**CALIFORNIA COASTAL COMMISSION**

## REVISED CONDITIONS AND FINDINGS

**Application No.:** 6-16-0024

**Project Description:** Removal of 11,300 lineal-feet of 6-foot high fencing along Silver Strand State Beach and replacement with a new fence. The southern portion of the fence to be approximately 6,300 lineal-feet, 6-ft. high above grade, with a mesh-grid of 2"x 6," and the northern approximately 5,000 lineal-feet portion of the fence to be 6-ft. high, with a mesh-grid of 6"x 6" for the portion parallel to Highway 75 and a mesh-grid of 6" x'6" for the 300-foot long portion perpendicular to Highway 75.

Design Master Double Wire Fence Contempo

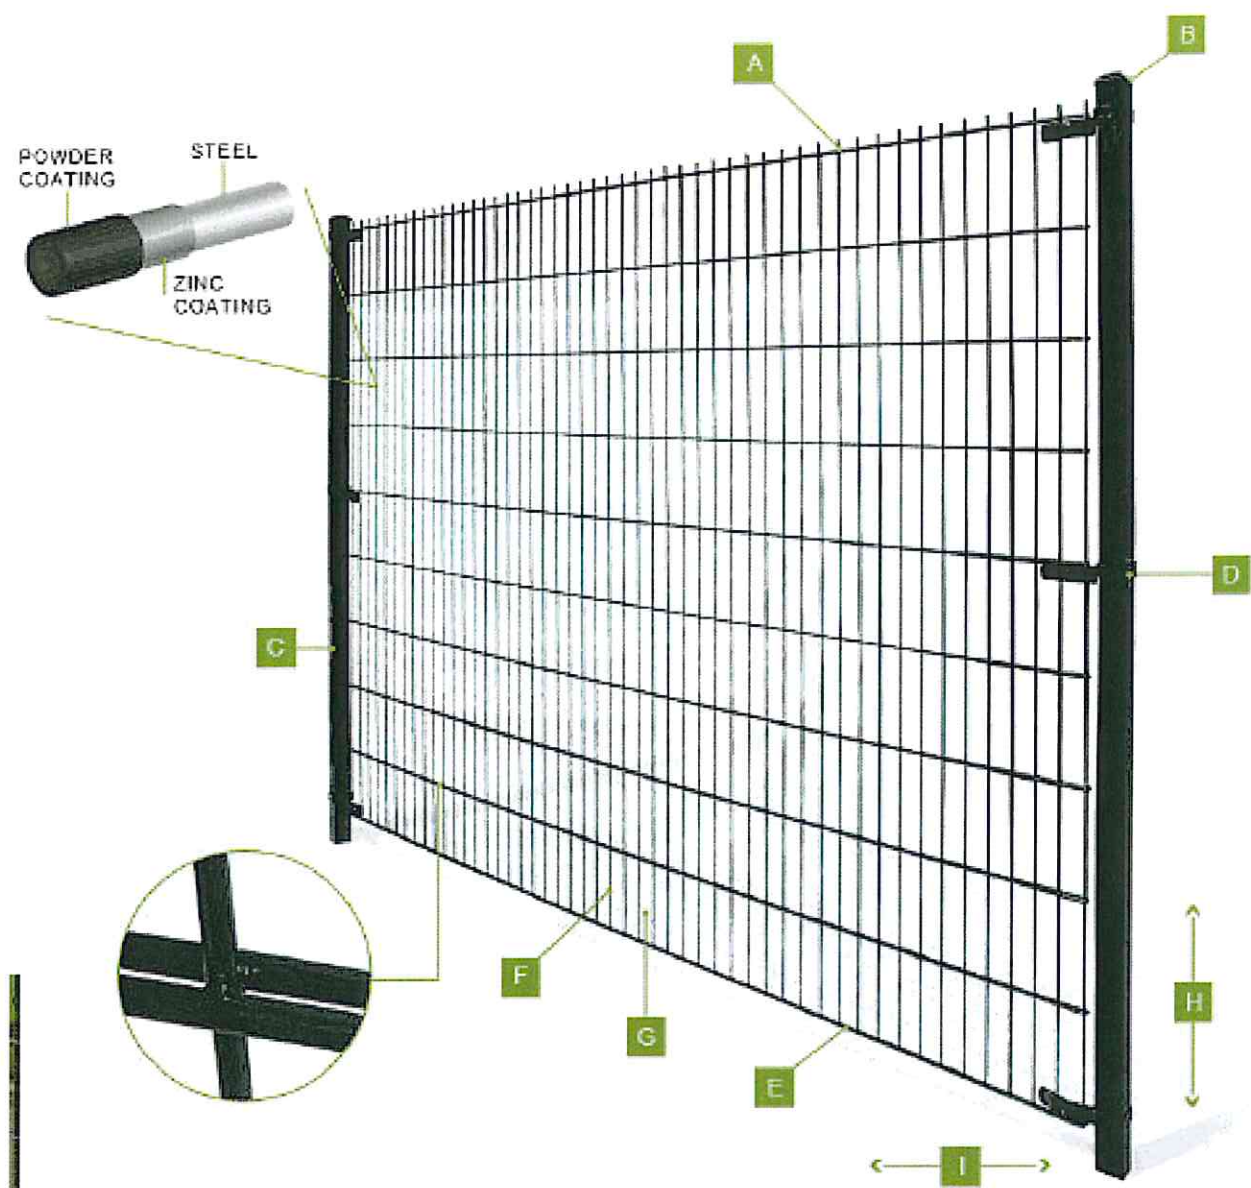
WILDCOAST has worked with stakeholders, including the City of Coronado, the Silver Strand Beautification Committee, and California State Parks, to help develop and provide input on a balanced plan that would remove the current dilapidated chain link fence from State Route 75 (Silver Strand). This area is a State of California designated scenic highway and is a critical link between the City of Coronado and adjacent trails, beaches, bikeways, and conservation areas. Over the last decade, this stretch of highway has seen improved public amenities, habitat protection, and views along the scenic highway. WILDCOAST would like to see this improvement continue in a balanced manner consistent with adjacent beautification and conservation efforts in south San Diego Bay.
